Sony Electronics Inc.
 Business and Professional Products Group
 Technical Publications
 3300 Zanker Road, San Jose, California 95134

Subject: **CORRECTING CRT FLASHING AND
 IRREGULAR WHITE BALANCE**

Model: **PVM-8040/8041Q/8043MD/8044Q**

Figure 1

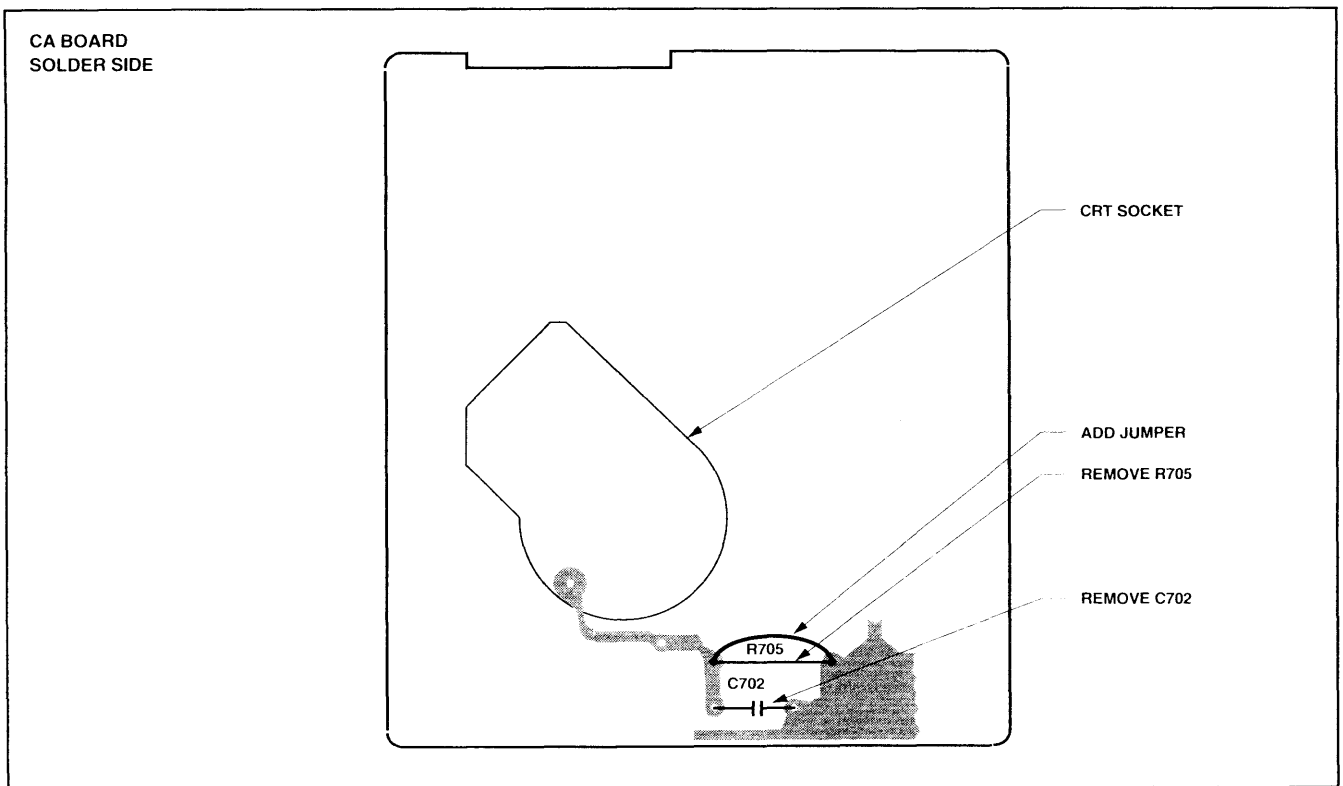
A flashing CRT or an irregular white balance in the video picture may be the result of an electrical discharge in the CRT. To correct this condition, a new CRT socket is now available as a replacement part. Perform the modification procedure described below.

**CA Board, Solder Side
 (See Figure 1.)**

1. Replace CRT socket with a new one.
2. Remove R705 and C702.
3. Solder a 15mm jumper on land vacated by R705.
4. Use RTV silicon glue (part no. 7-322-065-19) to secure the CRT socket to the CRT.

Former	→	New
CRT Socket 1-526-958-41	→	CRT Socket 1-251-244-11
